Golder Project No.: 123-92034

**RE: RESPONSE TO THE JUNE 29, 2015 CITY OF LOS ANGELES GEOLOGY AND SOILS
REPORT CORRECTION LETTER
PROPOSED RESIDENTIAL AND COMMERCIAL DEVELOPMENT
8150 SUNSET BOULEVARD, LOS ANGELES, CALIFORNIA**

- "Geology and Soils Report Correction Letter," Log # 83343-01 for Tentative Tract 72370 at 8150 West Sunset Boulevard, dated June 29, 2015.

PROJECT		8150 SUNSET BLVD. CITY OF LOS ANGELES, CALIFORNIA	
TITLE		MAP OF CPT, BOREHOLE LOCATIONS AND REINFORCED FOUNDATION ZONE	
PROJECT NO. 123-92034.02		FILE No. BoreholeLocationMap.mxd	
DESIGN	DL	12/18/2013	FIGURE 1
GIS	KJK	8/5/2015	
CHECK	CV	8/5/2015	
REVIEW	AH	8/5/2015	
SCALE: AS SHOWN		REV. 0

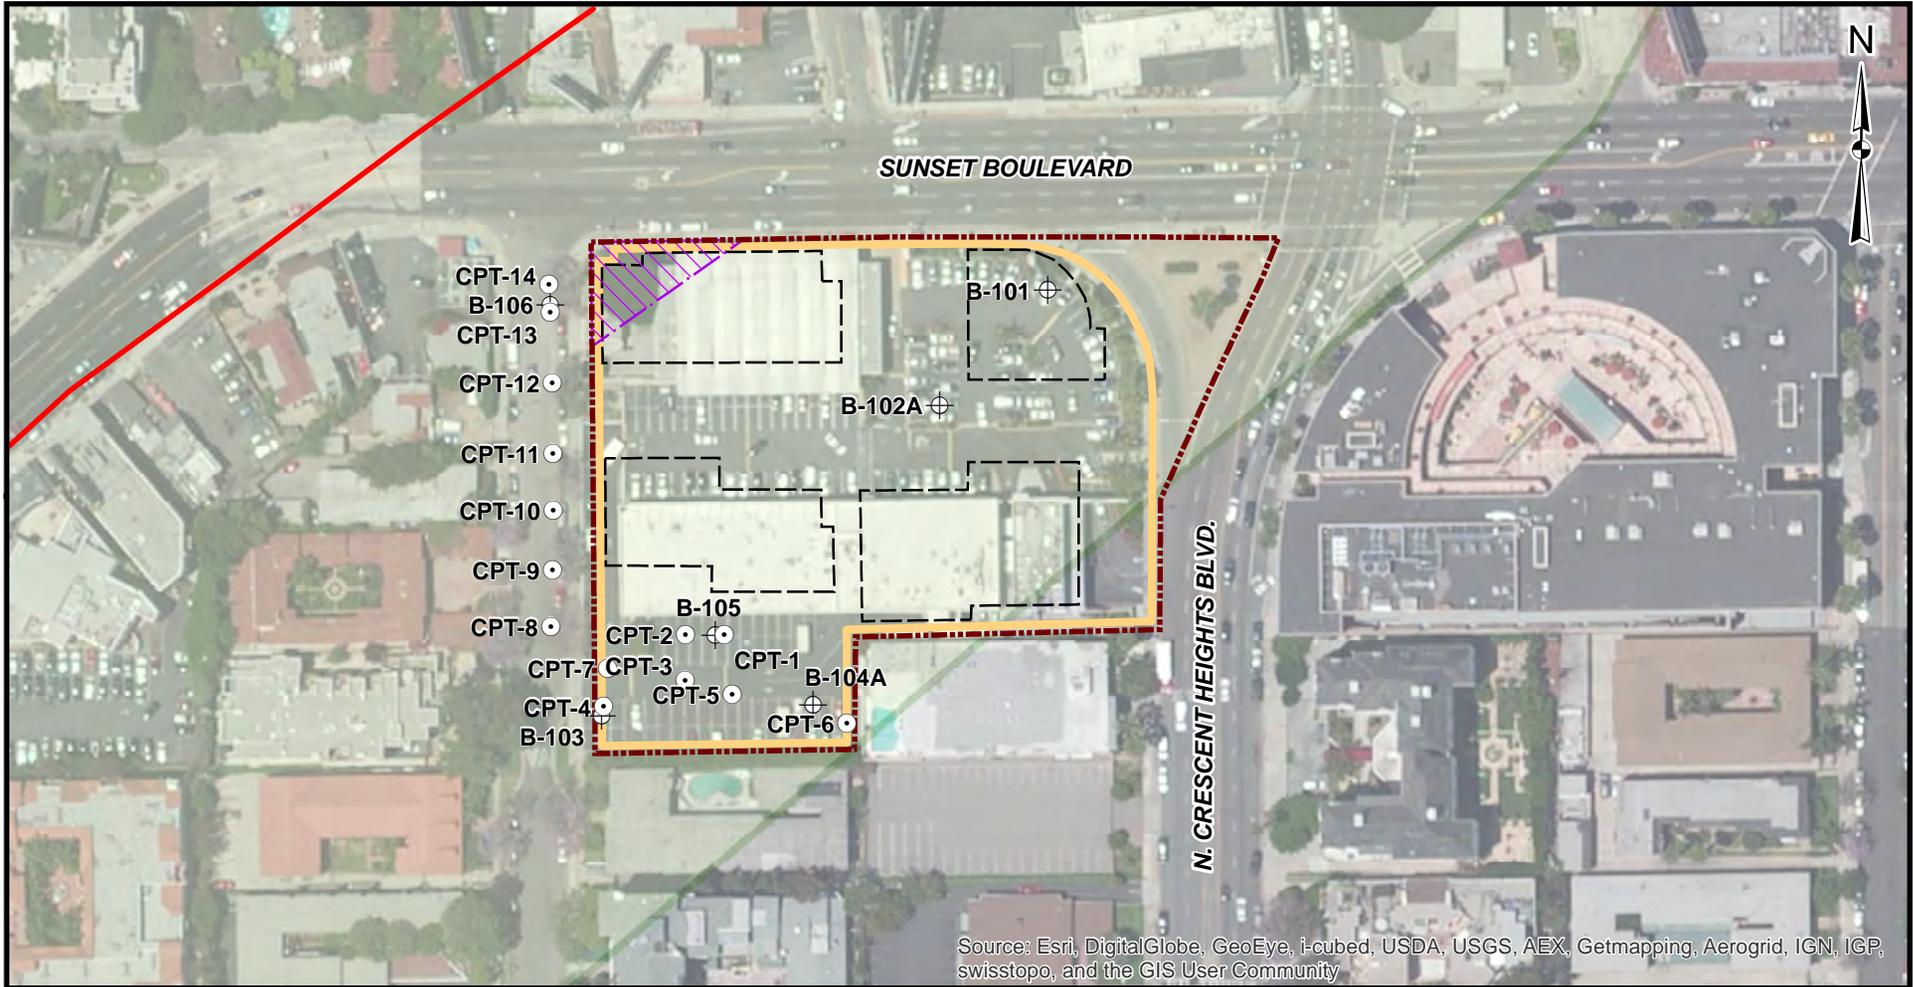
Based on the figure titled "Cross Section Locations" in the response report, a proposed structure is located at the northwest corner of the site. Provide geologic exploration 50 feet northwest of the structure (offsite) to determine the possible existence of an active fault within 50 feet of its planned location. Alternatively, show a setback area (building exclusion zone) or reinforced foundation zone on all site plans included in the reports.

As explained in Comment 1 of the previous letter, dated 11/21/2014, the Department does not except a zero setback without considering a reinforced foundation that accommodates off-fault deformation. As noted in the current reports, the Department (Grading Division) has allowed a zero setback for a structure that was designed 10 inches of horizontal and 2 inches of vertical offset deformation. This design was for a specific project at 1840 Highland Avenue, which was recommended by GeoPentech (project consultants). Review the previous geologic work for 1840 Highland and compare the geologic/fault conditions of that site with the subject site. If appropriate, and based on independent review, indicate that the recommendations for that project (foundations that accommodate 10 inches of horizontal and 2 inches of vertical offset) would be adequate for the proposed project on Sunset Blvd.

In light of the above, Golder has followed the City's policy and established a 50-foot wide reinforced foundation zone in the northwest corner of the site as shown on Figure 1 to this letter. This zone does not contain the main trace of the Hollywood Fault, but could be subject to secondary surface fault rupture or off-fault displacements. Secondary fault rupture displacements are expected to be less than the displacements on the main Hollywood Fault trace that is located an unknown distance northwest of the reinforced foundation zone.

Figure 1 to this letter presents a composite site map showing the proposed reinforced foundation zone, the location of the main trace of the Hollywood Fault, the extents of the Alquist-Priolo Earthquake Fault Zone, CPT and boring locations, and the approximate limits of the proposed basement excavation and building development. Figure 1 to this letter is also included in Addendum No. 1 to Golder's Geotechnical Report along with the above-described recommendations for the reinforced foundation zone.

Addendum No. 1 to Golder's Geotechnical Report contains Golder's recommendation that structures located within the reinforced foundation zone in the northwest corner of the 8150 Sunset Boulevard site be designed for a 10-inch horizontal ground displacement and a 2-inch vertical ground displacement.

Should the final proposed building footprint extend into the special foundation zone shown on Figure 1, then the owner may undertake further fault investigations surrounding the 8150 Sunset site. The purpose of these investigations will be to use subsurface investigations to establish whether a trace (main or secondary) of the Hollywood fault occurs within 50 feet of the final building footprint. If these proposed investigations prove to not be feasible (they will need to be located on part of Sunset Boulevard), then structures will be designed initially to accommodate 10 inches of left-lateral horizontal displacement and 2 inches of vertical displacement (up-to-the-north). Should the owner choose to build within the special foundation zone, then further analysis of the locations and orientations of known and possible faults will be undertaken at that time.

FIGURE 2
Results of Direct Shear Tests
8150 Sunset Boulevard, Los Angeles, California

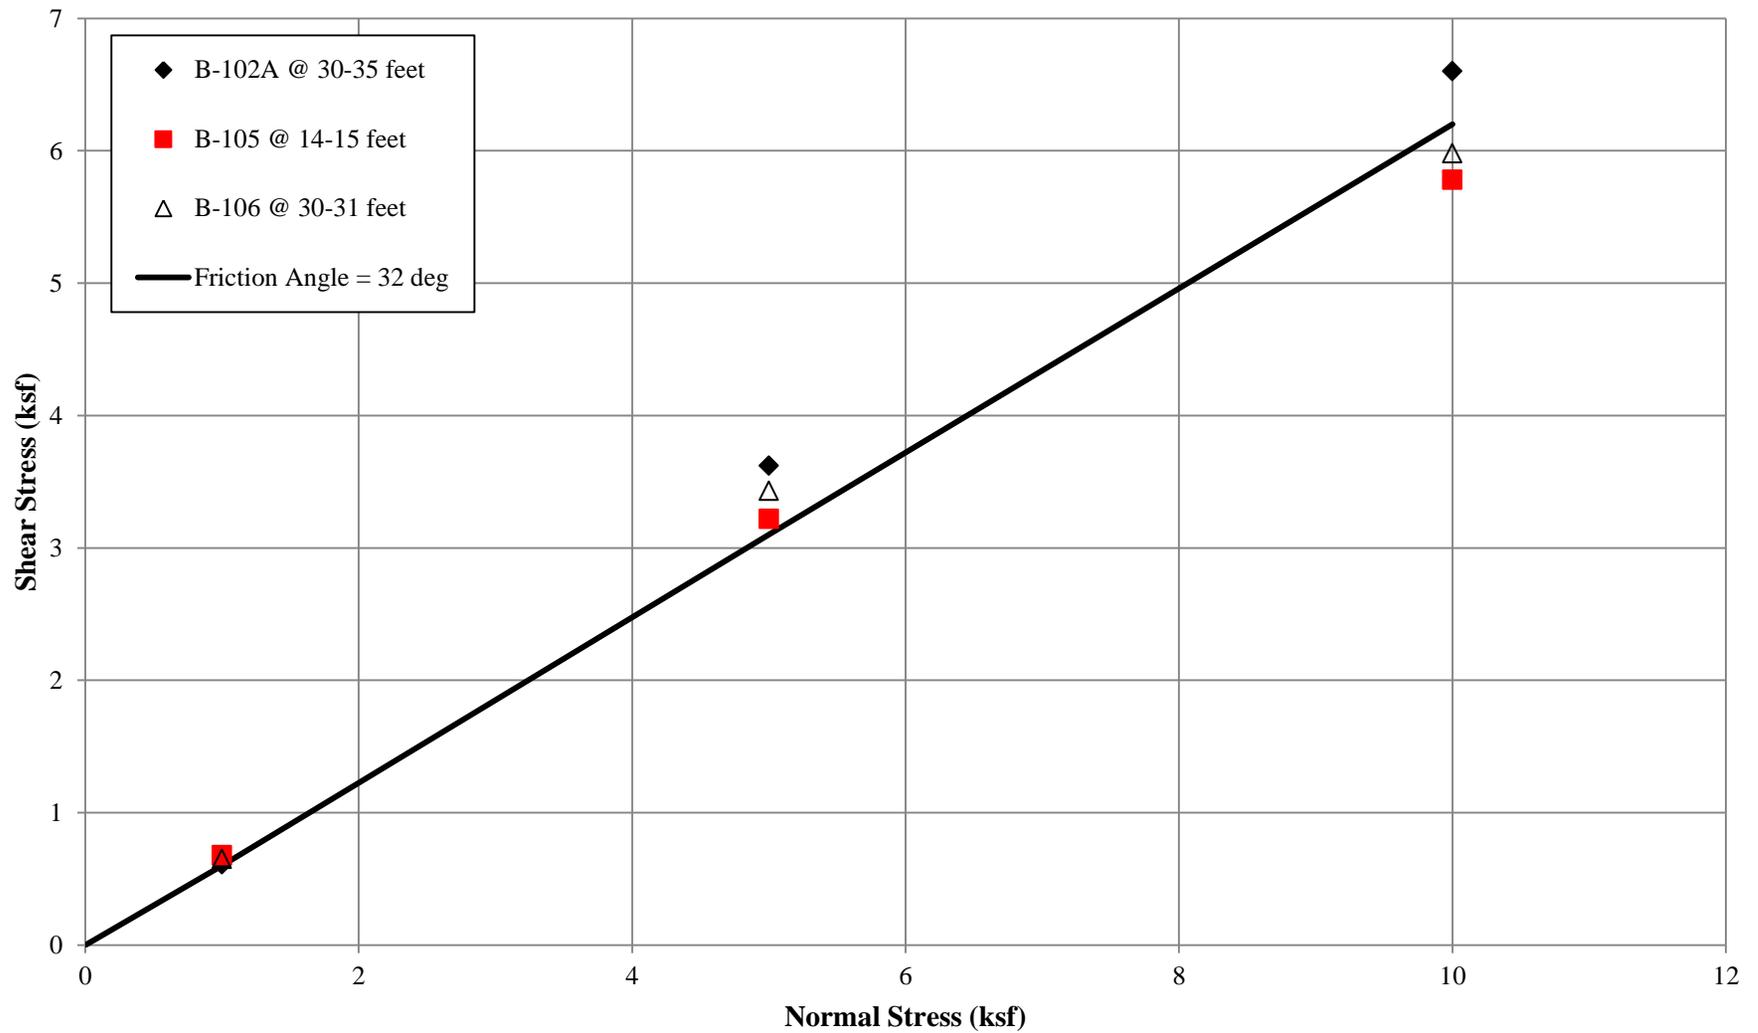
Regarding the response to Comment 6, the Department does not allow estimation of shear strength parameters for analyses. In addition, the values presented for widths less than 10 feet are much higher than calculated by Terzaghi's bearing capacity equation. Provide bearing capacities based on direct shear testing (3-points minimum) correctly calculated. Provide settlement analyses. Alternatively, use Code bearing values.

Comment 10 on the relatively low blow count data was to question the bearing capacity values recommended. The Department does not allow determination of the internal angle of friction, bearing capacities and pile skin friction by SPT or CPT data. Determine bearing capacity and/or skin friction by direct shear test results.

Regarding the response to Comment 11, the Department does not accept SPT/CPT derived shear strengths in long-term slope stability and retaining wall analyses. Provide saturated direct shear test data on the earth material to be retained, and utilize the saturated unit weights of earth materials in long-term slope stability and retaining wall analyses where these result in more critical computed factors of safety. (P/BC 2014-049)

Figure 2 to this letter presents a summary plot of shear stress at failure (i.e., shear stress at the end of the direct shear tests) versus normal stress for each of the three sets of direct shear tests. Figure 2 also shows a conservative best-fit linear failure envelope for the direct shear test data, with the cohesion intercept set at zero (which is appropriate for the granular soils at the site). As can be seen on Figure 2, the conservative best-fit linear failure envelope for the direct shear test data corresponds to a friction angle of 32 degrees (with a cohesion intercept of zero). Figure 2 and Attachment B to this letter are included in Addendum No. 1 to Golder's Geotechnical Report.

As described in Section 4.4 of Golder's Geotechnical Report, a friction angle of 32 degrees (with zero cohesion) was used in the calculation of bearing capacities of shallow foundations. Based on the direct shear laboratory test results described above and summarized on Figure 2, use of a friction angle of 32

As discussed in the response to comment 4 above, the results of laboratory direct shear tests on subsurface soils from the site, which are summarized in Figure 2 to this letter, have corroborated the friction angle of 32 degrees that was used to develop the allowable bearing pressures for shallow foundations that are given in Section 4.3.2 of Golder's Geotechnical Report. Therefore, the allowable bearing pressures in Section 4.3.2 of Golder's Geotechnical Report are valid.

As discussed in the response to comment 4 above, the results of direct shear tests on subsurface soils from the site, which are summarized in Figure 2 to this letter, have corroborated the friction angle value of 32 degrees that was used to develop the lateral earth pressure recommendations in Section 4.5 of Golder's Geotechnical Report. Therefore, based on the results of the direct shear tests, the lateral earth pressures provided in Golder's Geotechnical Report are valid.

FIGURE **3**

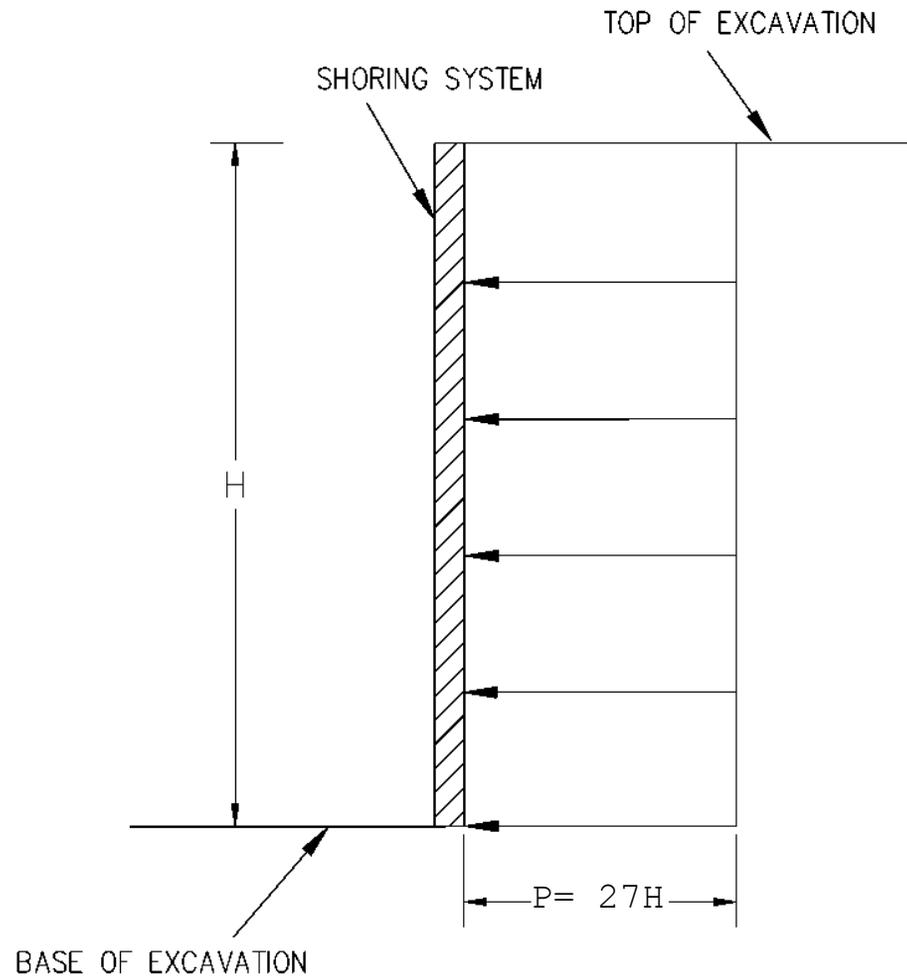
7. Regarding the response to Comment 13, provide recommendations for shoring, including the lateral earth pressure shoring is the retaining.

Where an excavation would remove lateral support (as defined in Code Section 3307.3.1) from an adjacent public way, property or structure, provide analysis demonstrating that shoring has an acceptable factor of safety ($FS \geq 1.25$) against failure based on the shear strength parameters of the earth materials the shoring is to support, at the most critical

Figure 3 shows the apparent earth pressure distribution that is recommended for shoring design. The recommended uniform apparent pressure distribution for sandy soils conforms to the standard practice in geotechnical engineering based upon measured strut loads in deep excavations. The cantilever portion of the wall down to the depth excavated to install the first brace/ground anchor should be checked separately using an equivalent fluid pressure of 39 pcf.
